MARATHON COUNTY PUBLIC LIBRARY
ADDITION AND REMODELING
WAUSAU, WISCONSIN

HSR L920154

JUNE 1993

HSR ASSOCIATES, INC.
Architecture/Engineering
La Crosse & Madison, Wisconsin

FIRST FLOOR LIGHTING PLAN
1/8" = 1'-0"

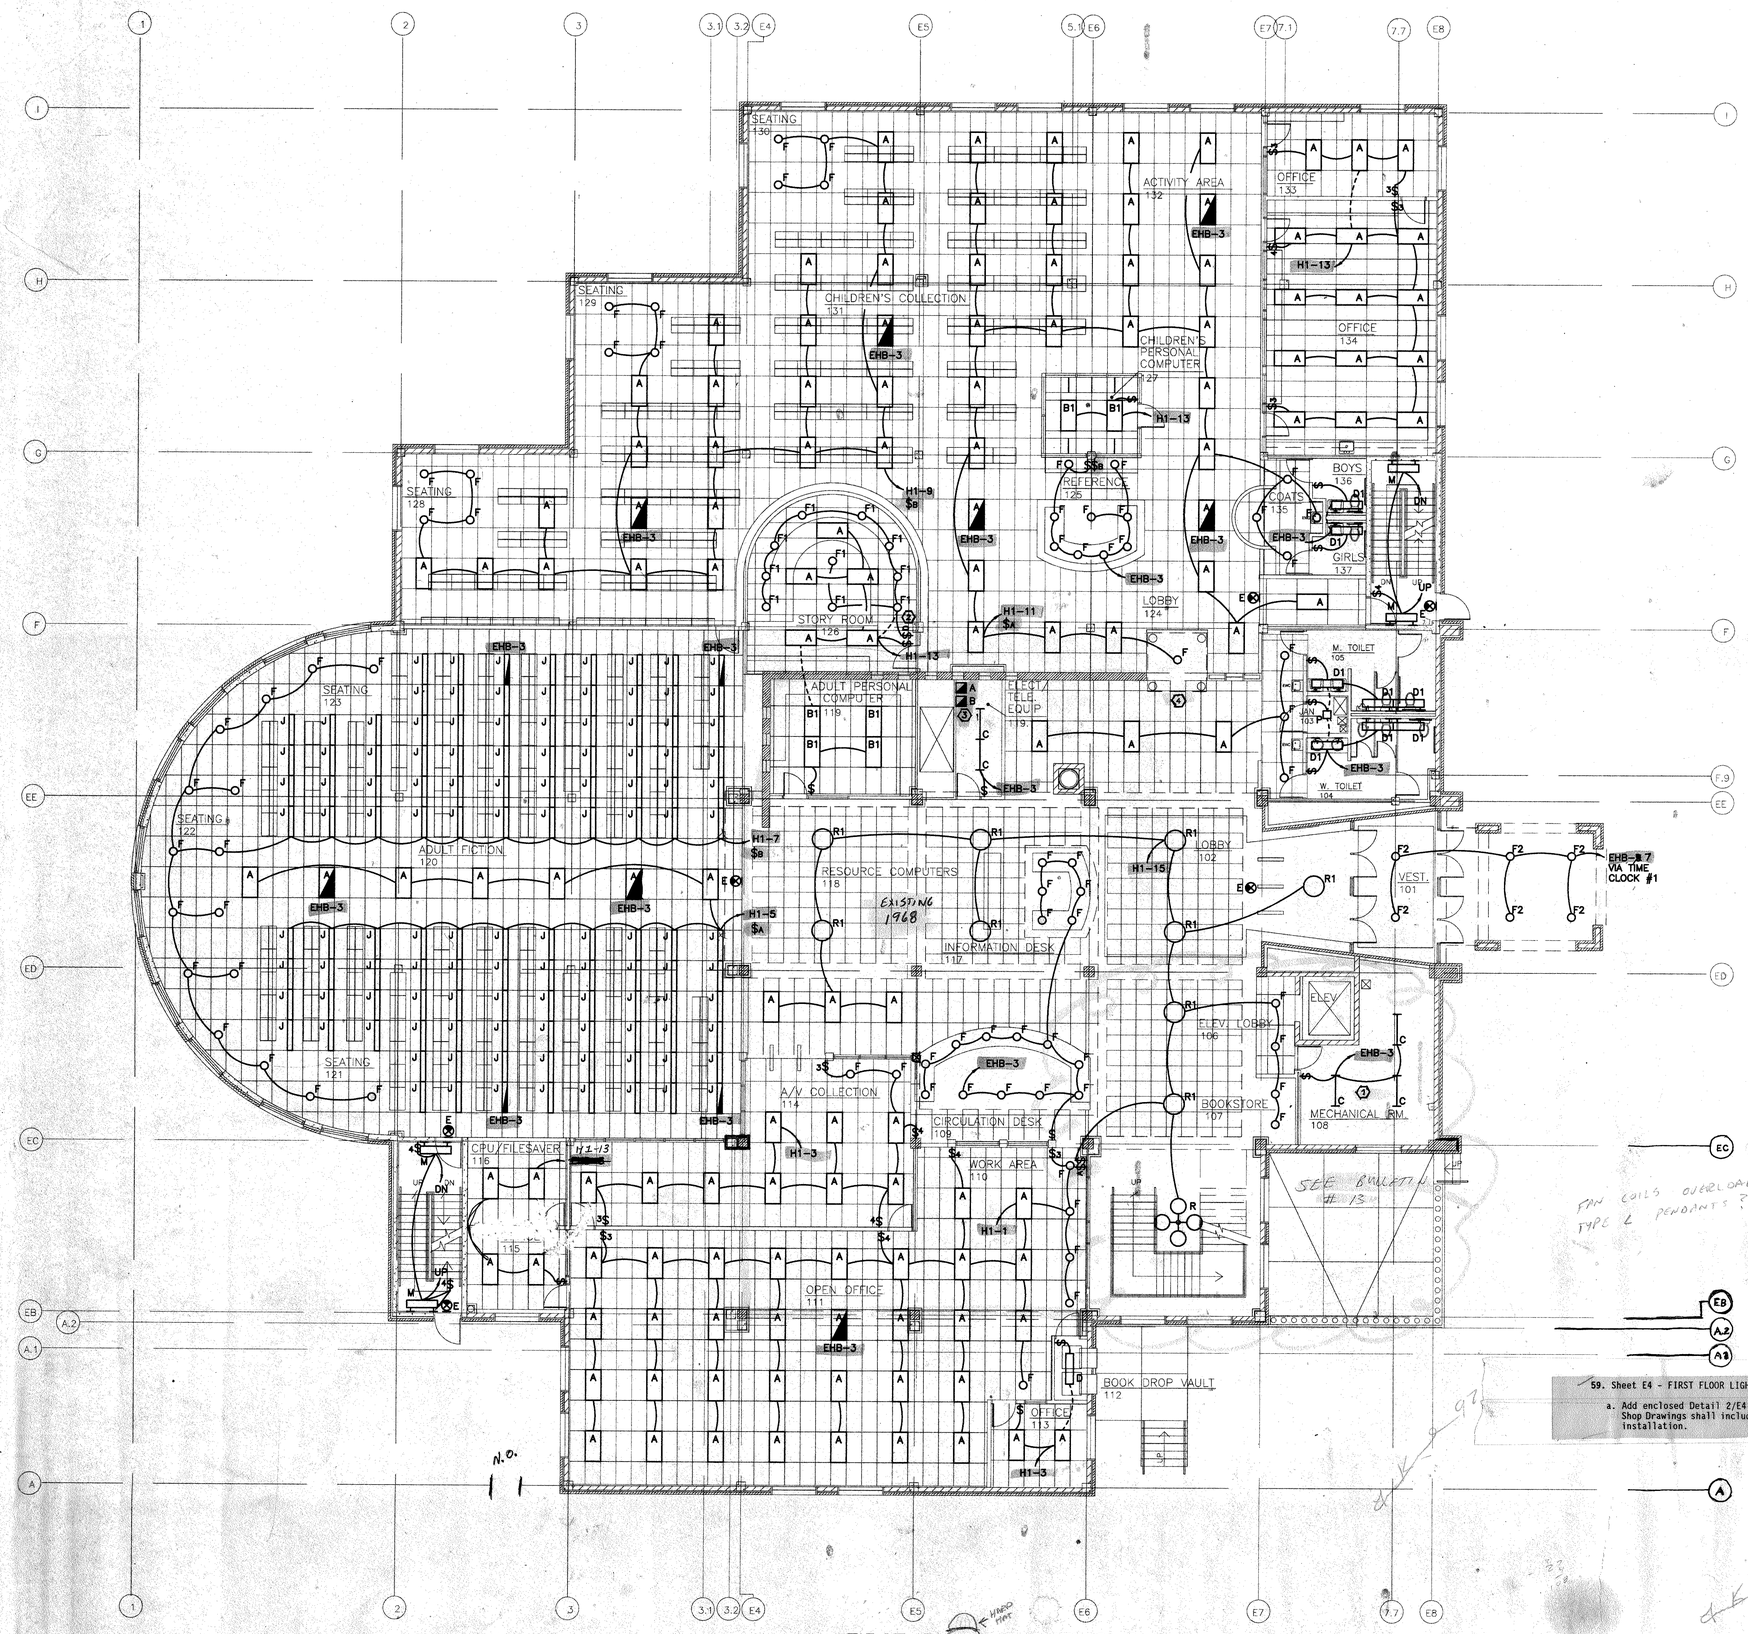
59. Sheet E4 - FIRST FLOOR LIGHTING PLAN.

a. Add enclosed Detail 2/E4(Sheet E15) to apply to Sheet E4. Light fixture Shop Drawings shall include an engineered drawing from the factory for this installation.

SECOND FLOOR LIGHTING PLAN

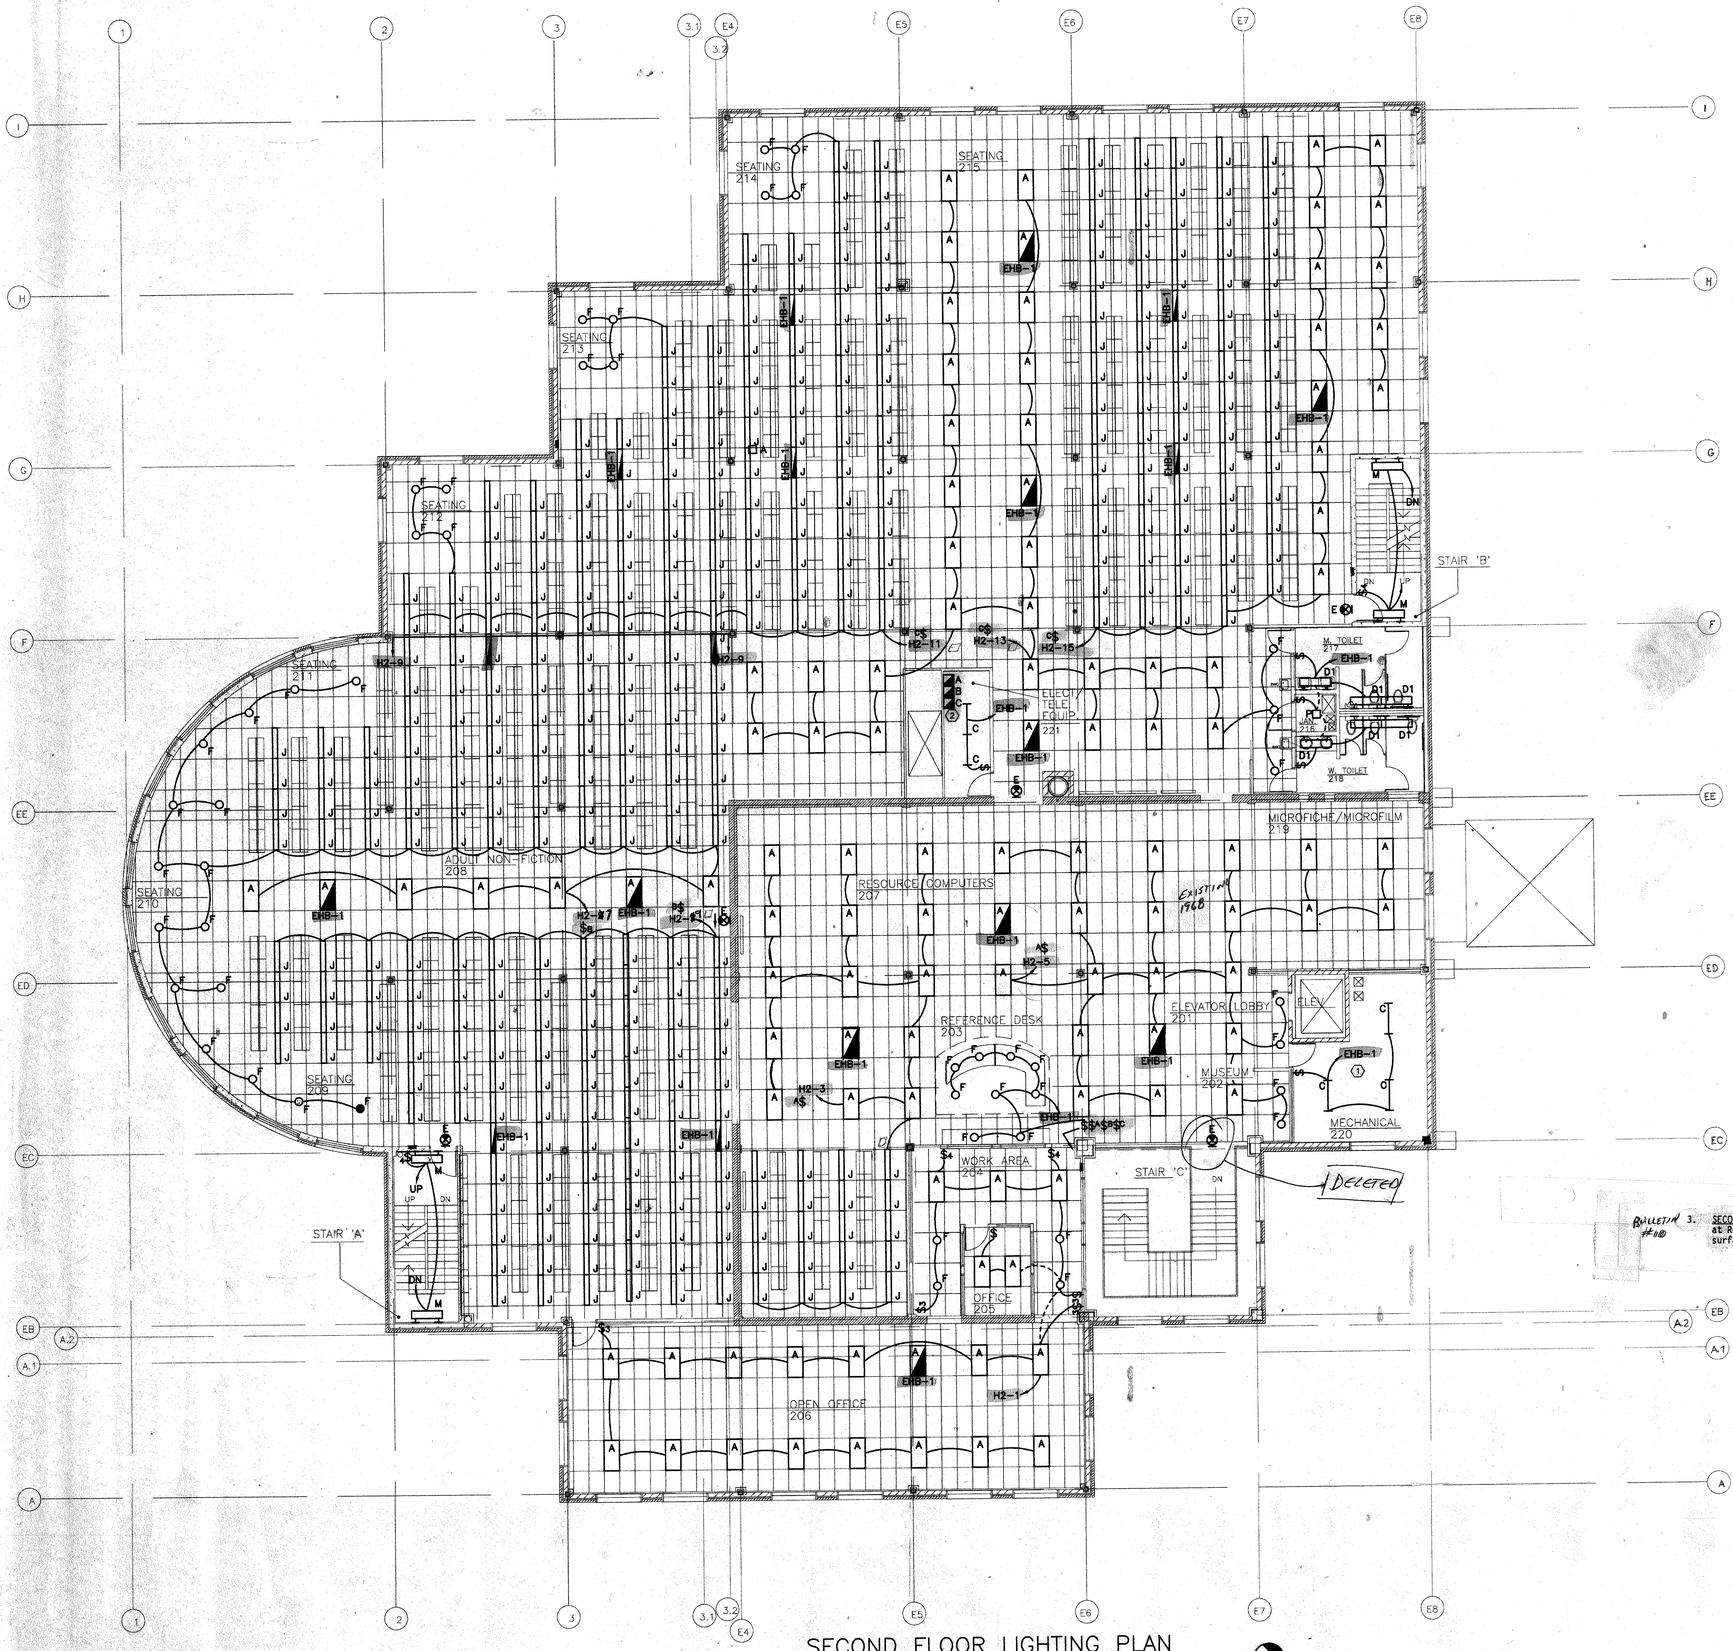
BULLETIN #10 3. SECOND FLOOR LIGHTING PLAN - SHEET E6. Recessed light fixtures type 'F' at Rooms 201 and 202 change to "Pescolite" #CFS 1026-782-277V white surface mounted downlight.
